Environmental Assessment of GX Technology Canada Ltd's GrandSPAN 2D Seismic, Gravity and Magnetic Survey, 2014 – 2018

GXT Responses to Consolidated Environmental Assessment Addendum Review Comments

7 July 2014

Figure 1. Comparison of Snow Crab Distribution based on RV Trawl Surveys and CPS Trap Surveys.
 Clockwise from top left: EA Figure 4.18; 2010 CPS results; 2011 CPS Results; 2012 CPS Results (Stansbury et al 2013)

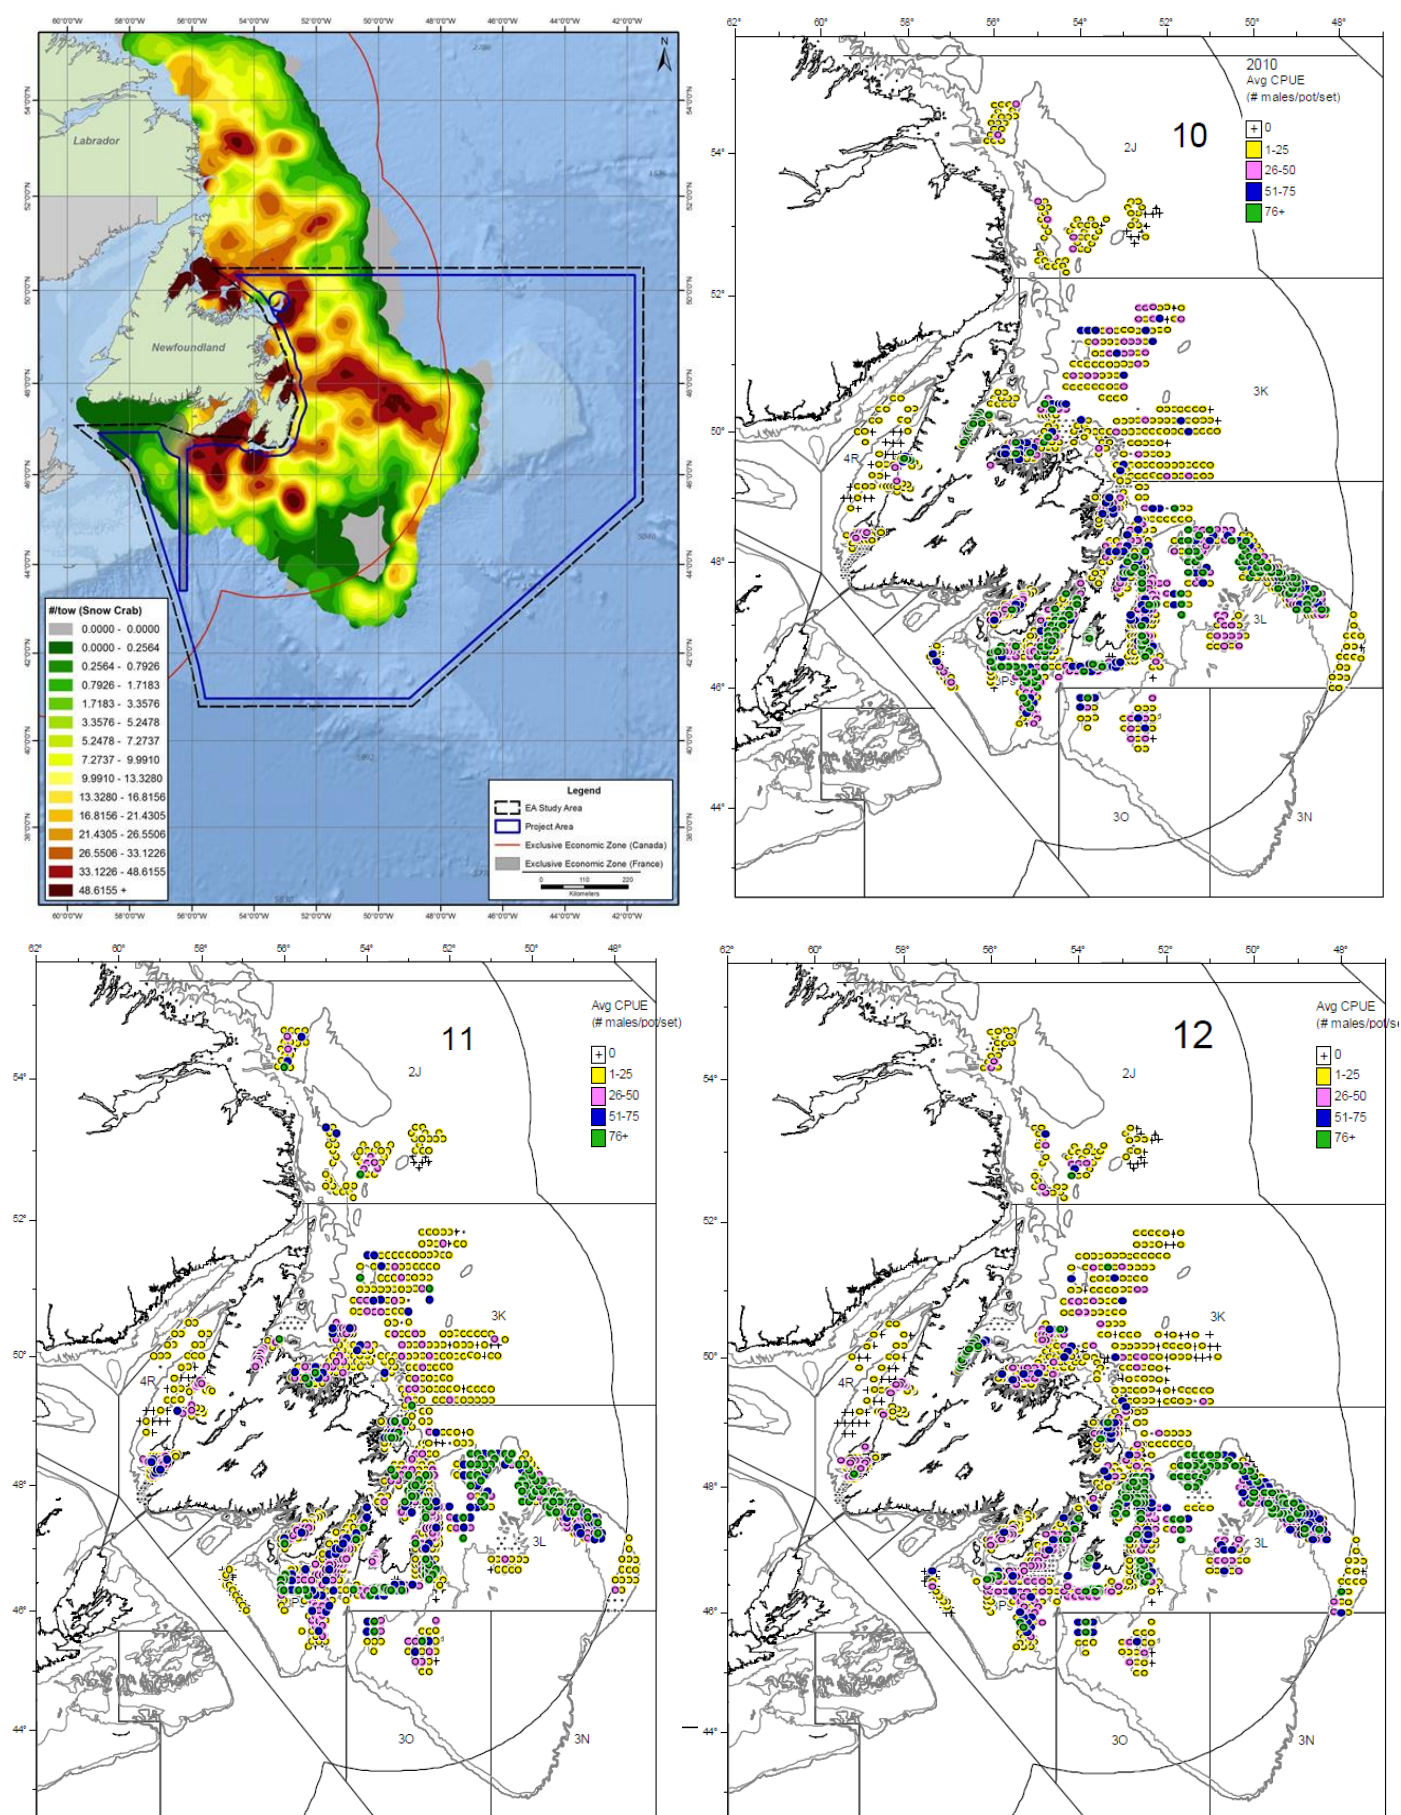
Original Comment: discussion on page 76 about Snow Crab relies on the DFO RV Trawl Survey, although the Industry-DFO Collaborative Post Season Trap Survey for Snow Crab has been found to be more reliable when it comes to the estimation of abundance.

FFAW|Unifor Response: The FFAW|Unifor has to reiterate that the DFO RV Trawl survey is used secondary to the Industry-DFO Collaborative Post-Season Trap Survey for Snow Crab when it comes to the distribution and assessment of snow crab in Newfoundland and Labrador waters.

GXT Addendum Response: GXT does acknowledge the importance and value of the Industry-DFO Collaborative Post-Season Snow Crab Survey, especially for the assessment and management of snow crab in Newfoundland and Labrador waters. EA Report Section 4.3.1.3 (Industry and Government Research Vessel Surveys) describes this survey and provides (in Figure 4.101) the locations of all the survey core stations.

As explained in the original response (above), the primary reasons for using the DFO RV surveys for the purposes of the EA was to allow for methodological and presentational consistency (in the accompanying Figures) across species, and to use a source that most closely matched the full geographic extent of the EA Study and Project Areas.

In its original comment, the FFAW|Unifor reviewer stated that the “discussion on page 76 about Snow Crab relies on the DFO RV Trawl Survey”. This, however, is not the case as the description of snow crab in the EA Report utilizes several relevant sources, including a key DFO document (cited on page 76 of the EA Report) related to stock status and abundance (Mullowney et al 2012), which is based explicitly on data from both the Collaborative Post-Season survey data and the RV trawl data. The same is true for Mullowney et al (2013).

In terms of coverage, the DFO RV survey encompasses a larger area than the Industry-DFO Collaborative survey, an area which better matches the GXT GrandSPAN EA Study Area, and so is most appropriate for the required geographical scope of the GrandSPAN EA. As Mullowney et al (2013) notes, “The CPS [Collaborative Post-Season] trap survey is more spatially limited than the multi-species trawl surveys, as it targets only portions of commercial fishing grounds.” Specifically, the RV survey includes the areas within the GXT Study Area surveyed by the Collaborative Post-Season survey plus other areas not surveyed by the Collaborative effort, such as the full “tail” of the Grand Banks, which is part of GXT’s proposed Project Area. Insofar as the RV and the CPS surveys do overlap, the indications of important concentrations of snow crab are very similar. Compare, for example, EA Report Figure 4.18, based on the RV survey data, with Figures 2 - 7, in Stansbury et al (2012 and 2013), which are based on the CPS data; Figure 1 below reproduces EA Report Figure 4.18 and representative figures from Stansbury et al (2012).

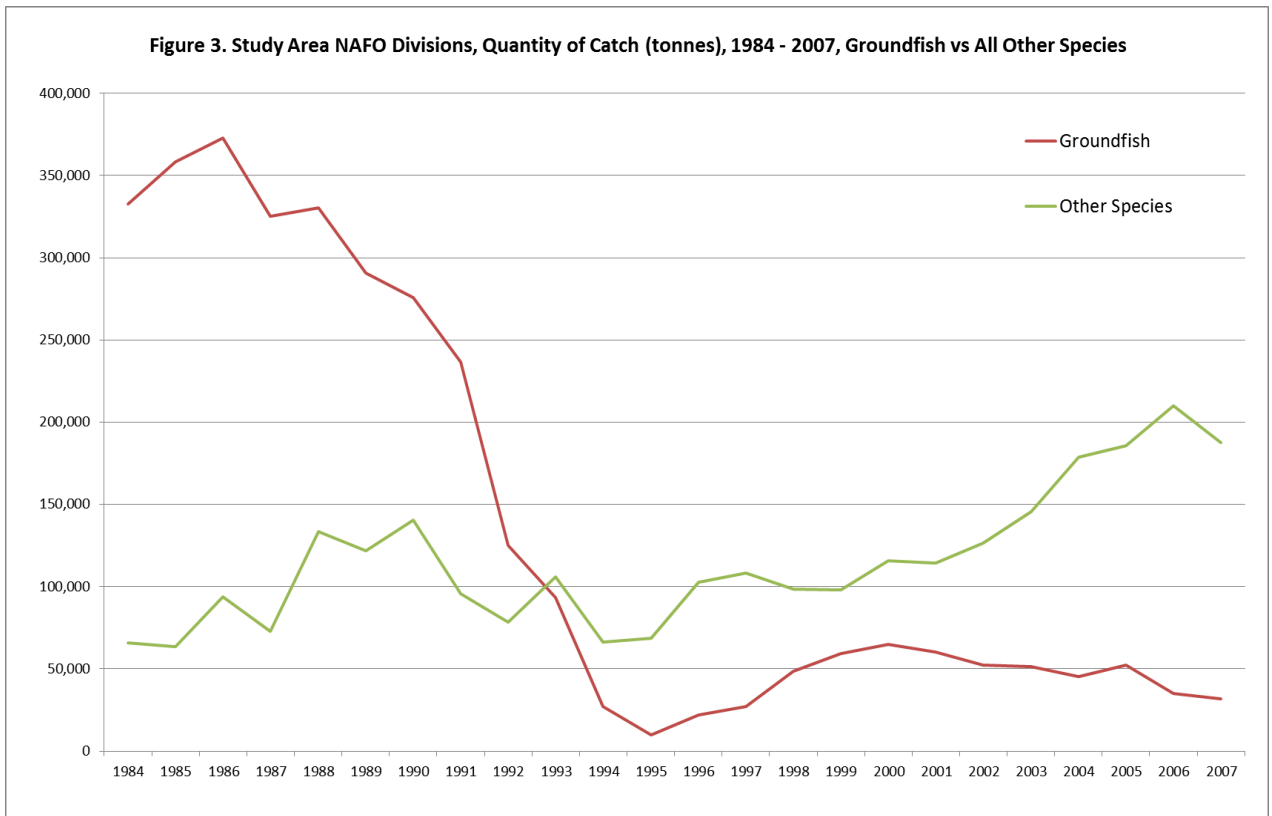
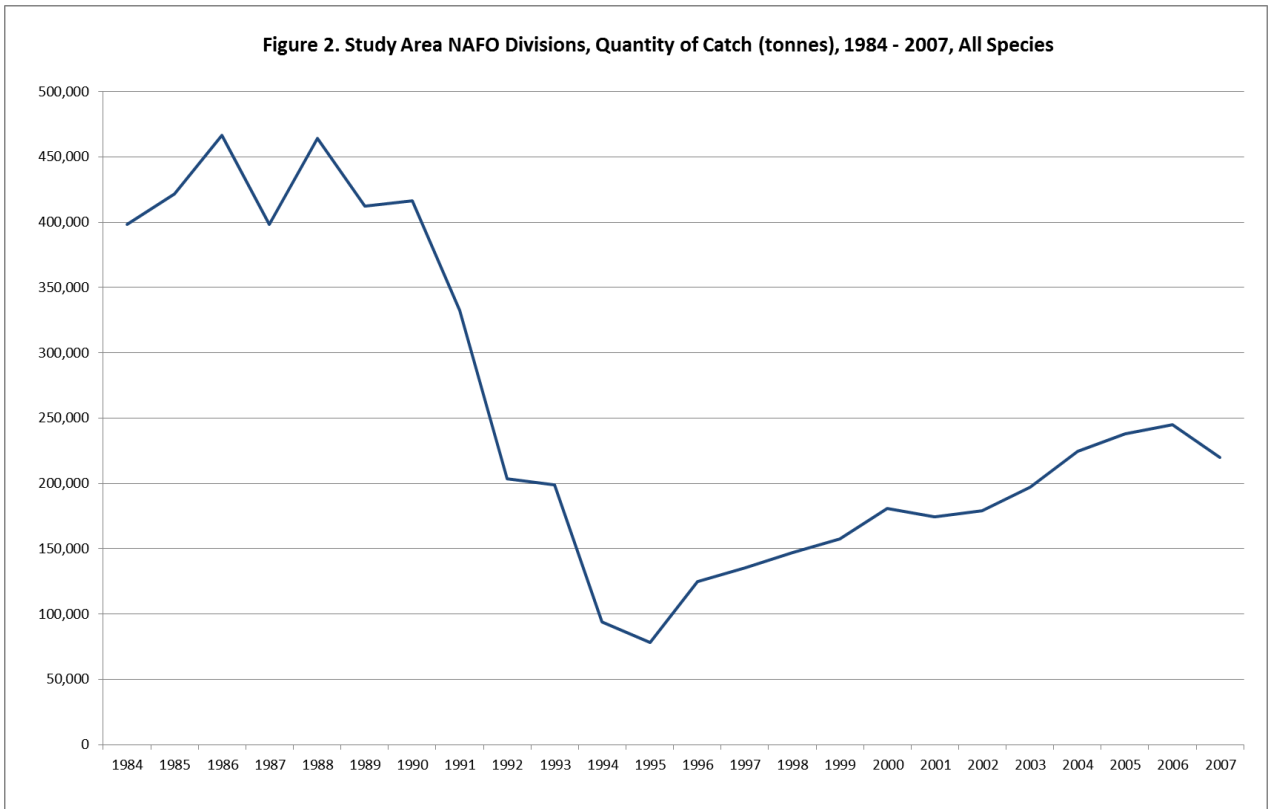
Original Comment: Harvesters and DFO scientists have strong evidence that we are already in a much warmer oceanographic regime, compared to the situation of the early 1990s. Further, when talking about future fisheries in the context of changing climatic circumstances, a discussion about the fisheries on the Ground Banks before 1990 would have been warranted.

FFAW|Unifor Response: The FFAW|Unifor notes the token mention of fisheries pre-moratorium but would suggest that something more substantiated would be warranted in light of the environmental changes.

GXT Addendum Response: GXT’s previous response (above) indicates where and how each of these items were addressed in the original EA Report, as stated in the requirements of the C-NLOPB’s EA Scoping Document. That discussion recognizes the changing and dynamic nature of the commercial fishing industry in Newfoundland and Labrador, particularly since the initial moratorium in 1992, which heralded the dramatic shift from groundfish to shellfish.

To supplement the discussion provided in the EA Report, as the FFAW|Unifor requests, the following additional graphs (Figures 2 and 3, below) are provided. These provide an indication of the fish harvest by quantity (weight, in tonnes) from 1984 to 2007, since the main focus of the data analysis in the current fisheries described in the EA Report (Section 4.3.1.2) starts in 2008. They present summary information on the key Grand Banks / Study Area NAFO Divisions (i.e. Divisions 3K, 3L, 3M, 3N, 3O and 3P) landings, specifically: 1) Overall quantity of harvest from 1984 to 2007 (Figure 2); and 2) a comparison of the harvest of groundfish vs. other species (Figure 3). Both illustrate the nature and scale of the changes which occurred after 1991.
